Environmental and Ecological Planning Advisory Committee

The 5th Report of the Environmental and Ecological Planning Advisory Committee
April 19, 2018
Committee Rooms #1 and #2

Col. Talbot Wetland Areas

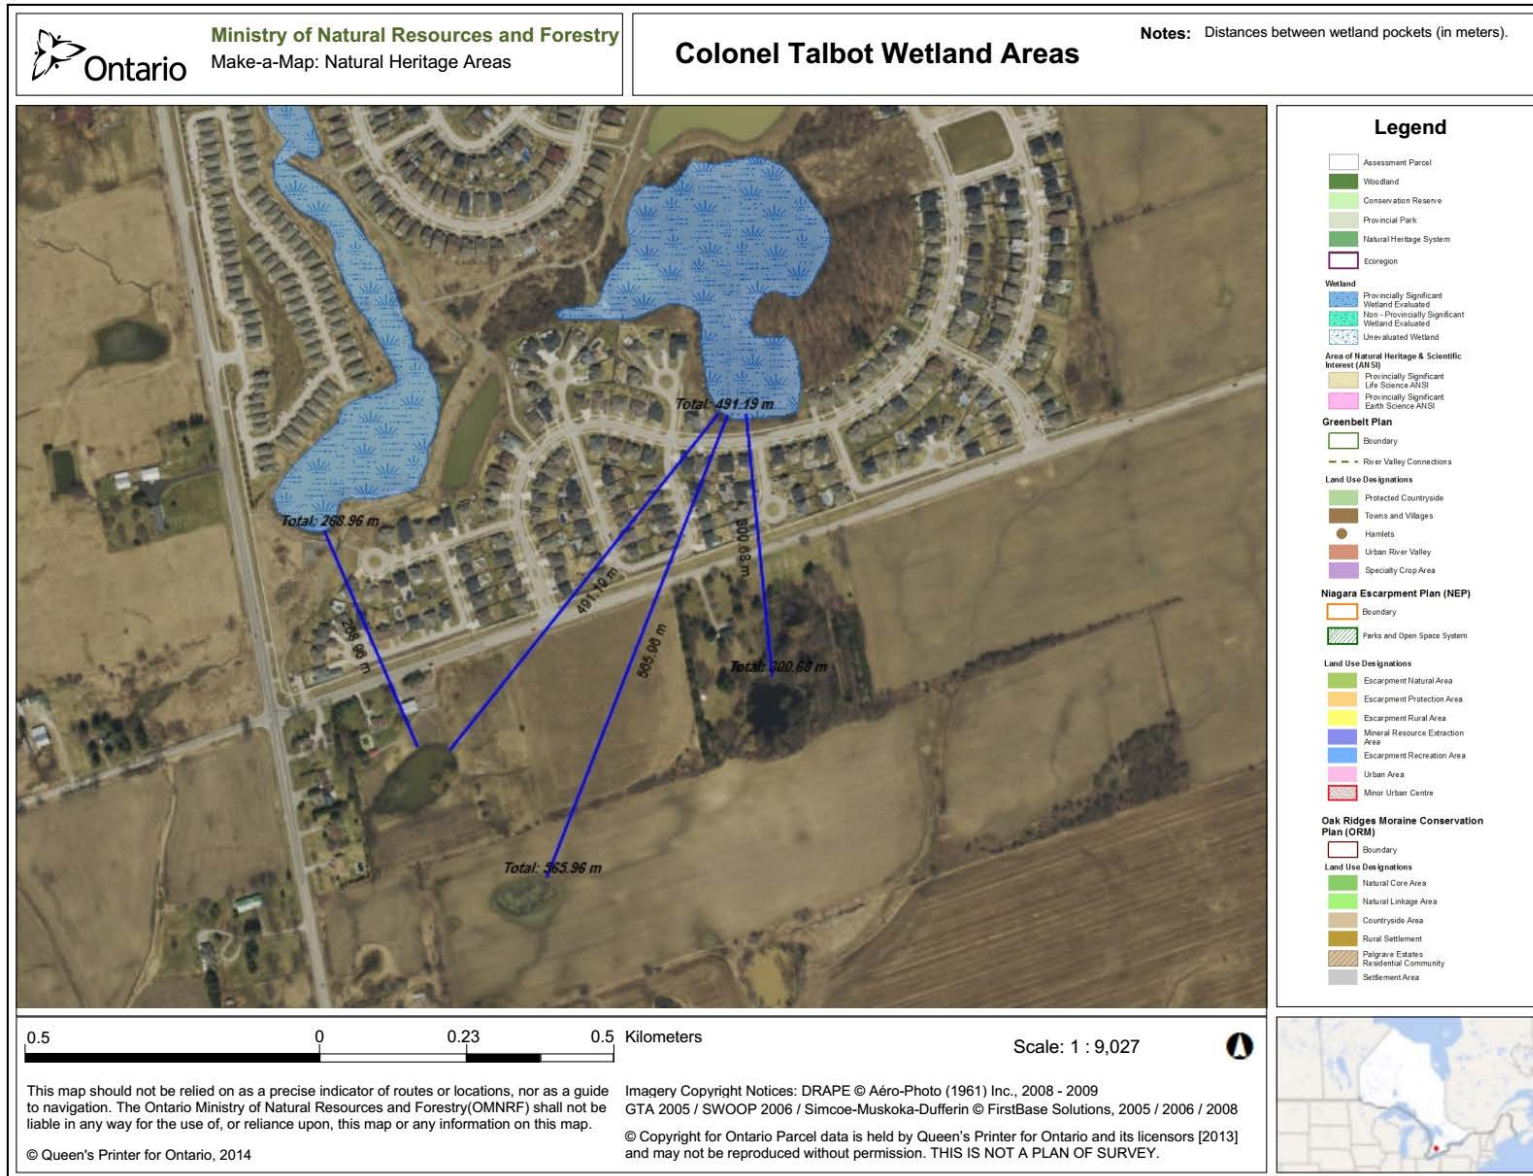
Agency Comments (UTRCA, February 27, 2017)	NRSI Response
	<p>amphibian breeding SWH), movement opportunities for anurans among the wetland units should exist. Both Pack Road and the existing residential development (within additional roads) immediately north of Pack Road present a significant barrier to amphibian movement. Please refer to the photo (date taken March 21, 2017) below which demonstrates the movement barrier, taken from the subject property looking east along Pack Road nearby the intersection of Pack Road and Settlement Trail. Also refer to the attached map (page 17 of this document), showing the significant distances between the wetland pockets within the subject property and those included in the PSW to the north. As can be seen from the airphoto included in that map, there is no natural connection between the wetland areas.</p>  <p>NRSI's position is that the on-site wetlands should not be complexed with the North Talbot Wetland PSW based on lack of landscape connectivity and movement corridors for anurans,</p>

Agency Comments (UTRCA, February 27, 2017)	NRSI Response
	<p>which results in functionally disconnected populations of breeding amphibians, and as such do not provide complementary biological functions. As well, based on exp's assessment, the wetlands on-site and those of the North Talbot Wetlands PSW are not connected hydrologically.</p> <p>NRSI has consulted with MNR staff and confirmed the approach described above for PSW complexing. Refer to text in Sections 5.1 and 6.0 of the updated SLSR.</p>
<p>SECTION 6.0 c) Downstream impacts to the fish recorded upstream of the culvert at Colonel Talbot and to the watercress located downstream of the culvert (coldwater indicator) will have to be assessed and discussed.</p>	<p>Ongoing consultation with study team; additional information to be provided once available.</p>
<p>SECTION 6.0 d) Please provide more details on the location of the wetland compensation area which should include the wetland that was removed/filled. Why is this suitable location? How will there be a net benefit? How will the wetlands and the soils be maintained? Please provide a map showing the potential locations of the wetland compensation areas, as well as appropriate buffers and a water balance analysis which demonstrates that the wetlands will survive. Please provide a monitoring plan for the wetland compensation area which must be provided within in the limits of the draft plan and as such, the limits of Phase 1 may need to be revised.</p>	<p>Details of the proposed wetland compensation plan and area are not yet available. Once the preliminary details are available, they will be circulated to the reviewing agencies for comment.</p> <p>It is anticipated that the proposed wetland compensation plan will be a standalone document.</p>

RE. UTRCA Comment 6.0(b):

Photographic Evidence

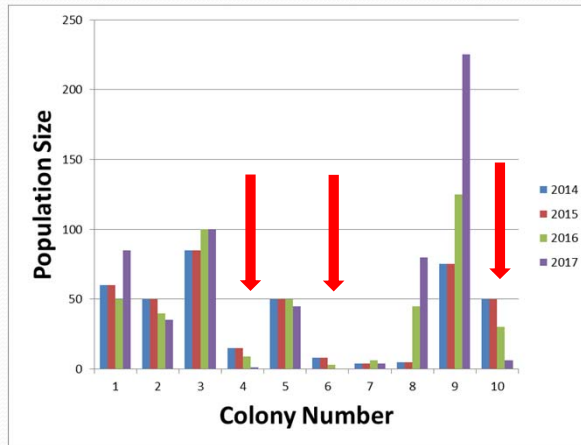
- Photographs (Dillon 2015, 2016, 2018) indicate an initial reduction in goutweed; the 2017 photos indicate an increase from 2016
- The effects of restoration on False Rue-anemone are uncertain because acceptable limits and targeted outcomes, as well as measurements to determine these, were not clearly described before the action.
